**SUBJECT: PALISADES NUCLEAR PLANT – STAFF ASSESSMENT OF RESPONSE TO
10 CFR 50.54(f) INFORMATION REQUEST – FLOOD-CAUSING MECHANISM
REEVALUATION (CAC NO. MF6128: EPID L-2015-JLD-0003)**

STAFF ASSESSMENT BY THE OFFICE OF NUCLEAR REACTOR REGULATION

PALISADES NUCLEAR PLANT

Figure 3.2-1. Map showing the key structures and identification numbers for the critical locations at safety-related structures of Palisades Nuclear Plant (Adapted from FHRR Figure 3.2-1). Locations are identified by numbers consistent with Table 3.2-1.

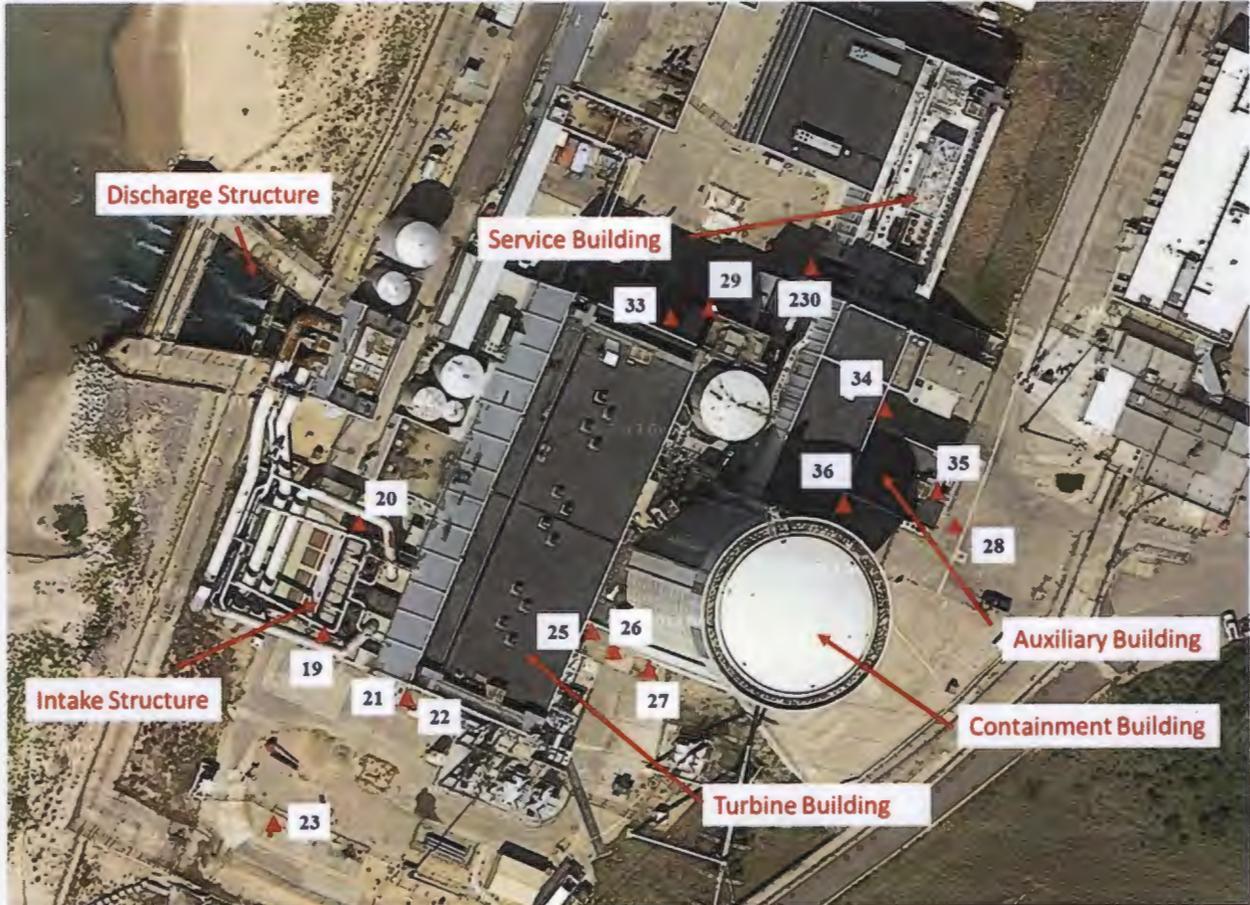
The FLO-2D model includes inland and lake boundaries. The licensee assigned a normal depth flow to the grid elements along the inland boundary and a constant stage for the model boundary condition along Lake Michigan. In its FHRR, the licensee conservatively determined the constant lake elevation based on the highest recorded monthly-mean elevation of Lake Michigan, 583.2 ft. NGVD29. The licensee used this value as a “reservoir water elevation”, a feature of the FLO-2D model, assigned as a model boundary condition to all grid elements in the Lake Michigan portion of the model. The NRC staff examined the licensee’s model input files and found that no “reservoir water elevation” was assigned in the model. The licensee revised its FLO-2D model by assigning maximum monthly mean lake level of 583.2 ft. NGVD29 over a surface depression zone close to the model’s western boundary. The licensee demonstrated that adding the lake boundary condition to this portion of the FLO-2D model has a minimal effect on the maximum WSE at critical locations (NRC, 2016c); these locations were identified as critical in the FHRR (Entergy, 2015) and shown in Figure 3.2-1.

The NRC staff reviewed the revised input and output files and found that the reservoir assigned in the model was filled up to the specific lake level (583.2 ft. NGVD29) within the first time step (0.1 hour), but was not maintained at the specified lake level for the rest of the simulation period (24 hours). The lake level dropped by about 2 ft. through the simulation period. Therefore, the NRC staff determined that using the reservoir method to define the boundary condition along

the lake in a FLO-2D model does not correctly reflect a constant lake stage over the LIP event as assumed by the licensee. The NRC staff performed an independent run by using the stage-time relationship function available in the FLO-2D model. In this approach, the specified lake level is maintained at 583.2 ft. NGVD29 throughout the simulation period. The NRC staff's examination of results from this model run indicate that the maximum WSEs at the critical locations have a minimal increase. On the basis of the results, the NRC staff agrees with the licensee's conclusion regarding minimal effects of the lake boundary on the critical locations.

The model results for the LIP analysis indicate that the maximum WSEs at the Palisades site range from 592.5 ft. NGVD29 near the North Entrance to the Screen House/Intake Structure (See Figure 3.2-1; location 20) to 626.1 ft. NGVD29 at the Administration Building Hallway East Entrance (see Figure 3.2-1; location 35). The licensee evaluated 15 critical locations as shown in Figure 3.2-1 and found that most of them have maximum WSEs below the protection elevation of 594.4 ft. NGVD29, except for four that are located at ground surface above 594.4 ft. NGVD29. The maximum water depths at these four locations ranges from 1.0 ft. to 2.2 ft.
